AMERICAN
STRUCTUREPOINT
INC.

December 15, 2014

Re: Additional Information Document
Des. No. 0400587
State Boulevard Reconstruction Project
between Spy Run Avenue and Cass Street
Fort Wayne, Allen County, Indiana

Figure 1: Consulting Parties Alternative Configuration

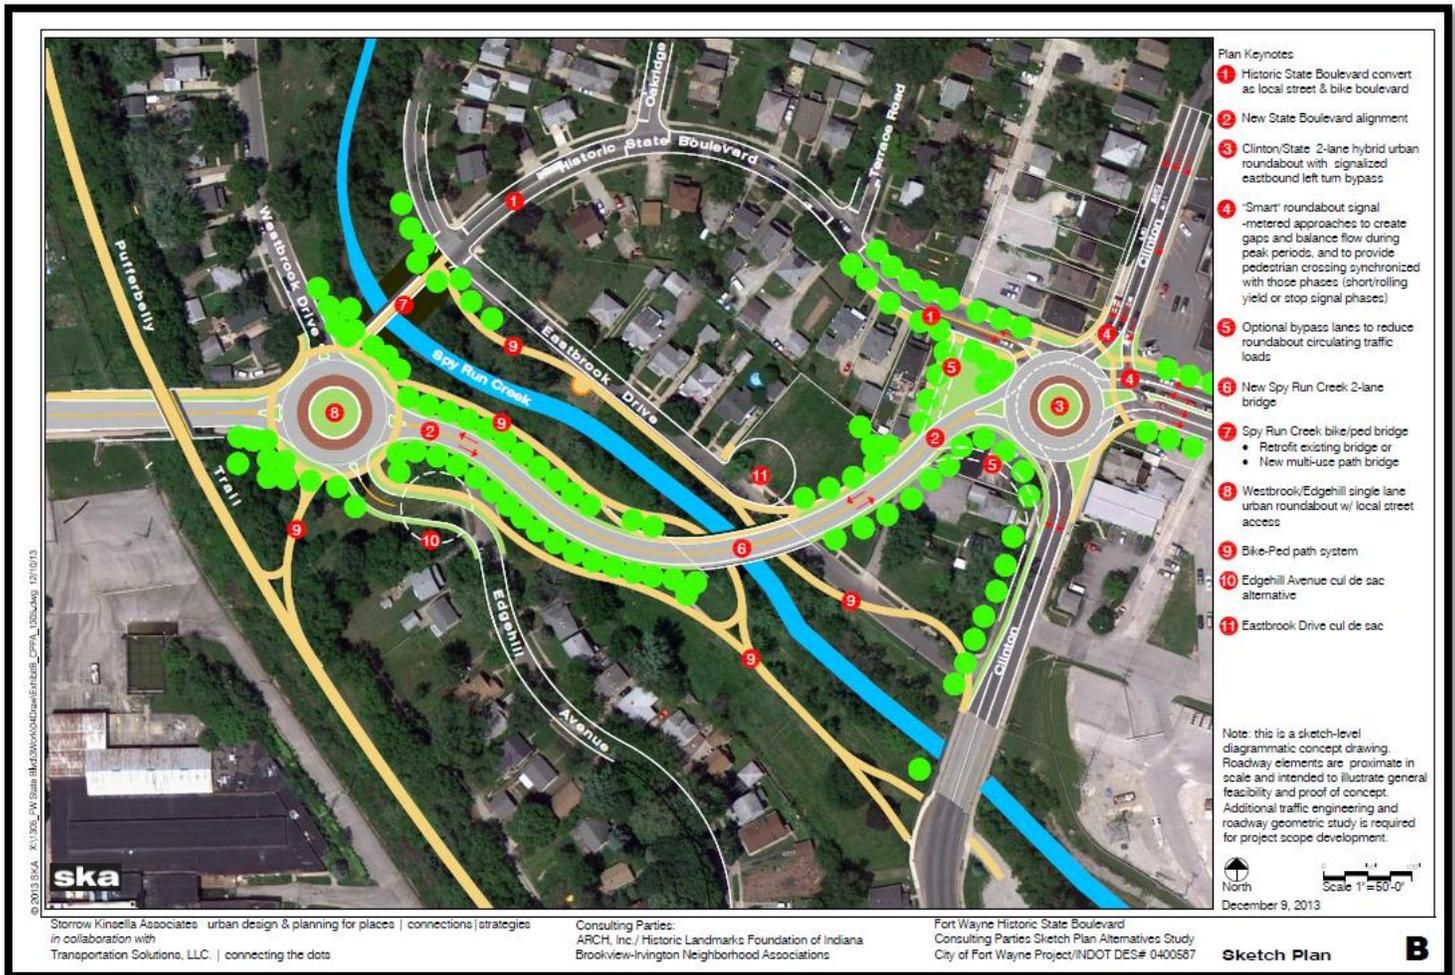
The CPPA includes a two-lane roundabout with a southbound left turn bypass lane. The accommodation of this bypass lane into the design of the roundabout would require that the entering and exiting flow on the east leg (State Boulevard) of the intersection be signalized. The CPPA also includes approach metering in order to provide gaps for certain approaches when heavy flows begin to dominate upstream approaches. Roundabout metering consists of one or more legs with queue detectors and one or more legs with metering signals. Once the queue extends such that the queue detectors are activated, the metering signal(s) turns red, stopping traffic on upstream approaches temporarily and allowing the queue to dissipate on the downstream approaches.

In a meeting with the City of Fort Wayne, Indiana Department of Transportation (INDOT), and the Federal Highway Administration (FHWA) regarding the CPPA, FHWA and INDOT directed American Structurepoint to analyze the capacity of the CPPA without the southbound left turn bypass. Because a left turn bypass at a roundabout is an unprecedented treatment in the United States, the decision was made by FHWA and INDOT that such treatment was not desirable from a drivers' expectancy standpoint. For the CPPA as shown in **Figure 1** of this memo, a left turn bypass from southbound Clinton Street to eastbound State Boulevard requires a motorist to complete a left turn movement by deflecting to the left of the splitter island when approaching the north leg of the roundabout. It is counterintuitive for the motorist to be required to be on the left side of

the splitter island when approaching the roundabout. Hence, such treatment is undesirable and confusing for drivers who are used to driving through conventional roundabouts in the United States.

Based on the capacity analysis results shown in **Tables 2 and 3**, it can be concluded that a roundabout with approach metering will not provide acceptable levels of service (LOS) to alleviate traffic congestion and meet the purpose and need of the project. NIRCC has established a Level of Service “D” as the acceptable peak hour service level for intersections and corridors within the urban area. A LOS of A thru D is considered acceptable and is an indicator of acceptable delay and level of intersection congestion. As shown in **Tables 2 and 3**, the overall intersection LOS is E or F in all but one peak hour. The unacceptable LOS associated with the analysis of the CPPA indicates that the intersection would exhibit intersection traffic operations at LOS E or F and would not function at an acceptable level of congestion, and thus this alternative would not meet the purpose and need of the State Boulevard project.

Figure 2: Scenario 1 and Scenario 2 Lane Configurations

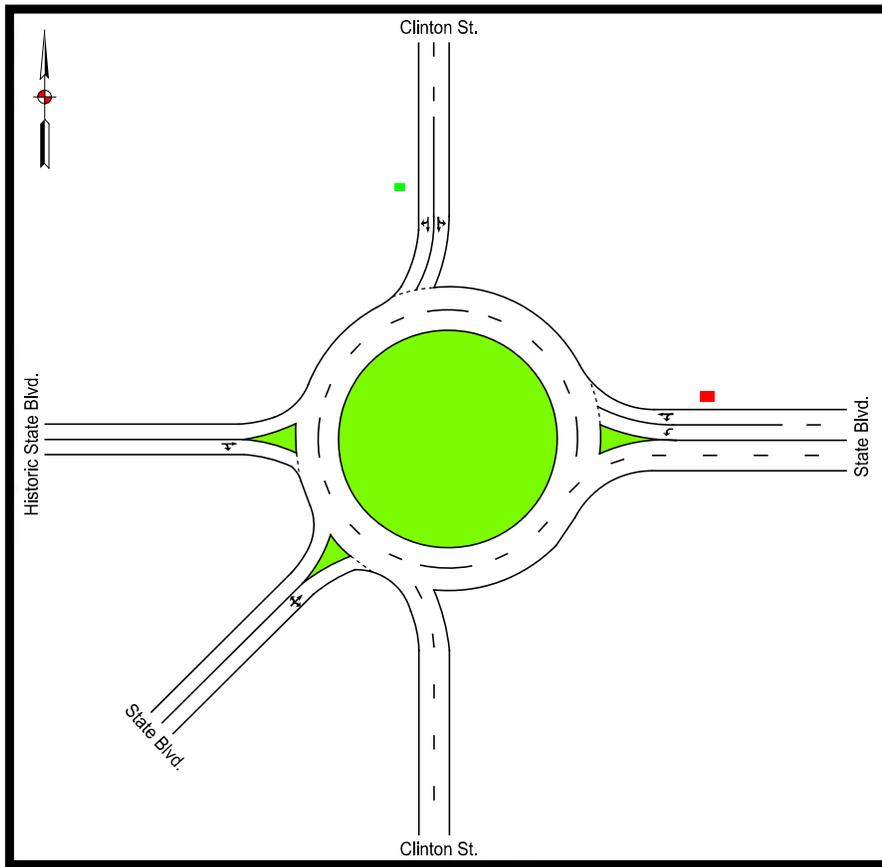
- Original 2005 AM and PM Peak Hour traffic volumes
- CPPA Lane Configurations for roundabout and all approaches, except no southbound left-turn bypass. Lane configurations are shown in **Figure 2**.
- Roundabout metering – queue detectors installed on the north approach and metering signal on the east leg of State Boulevard

Figure 3: Scenario 3 Lane Configurations

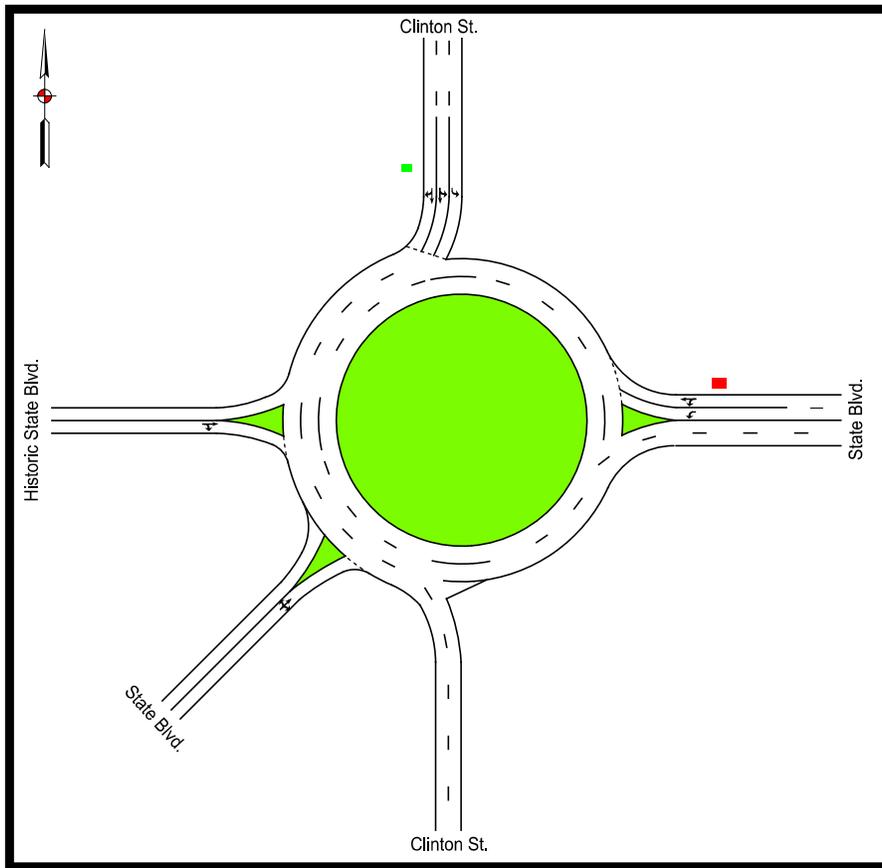
- 2009 AM and PM Peak Hour traffic volumes from NIRCC
- Addition of one southbound approach lane that acts as a dedicated left turn lane for southbound to eastbound traffic (in lieu of a left turn bypass). Lane configurations are shown in **Figure 3**.
- Roundabout metering – queue detectors installed on the north approach and metering signal on the east leg of State Boulevard
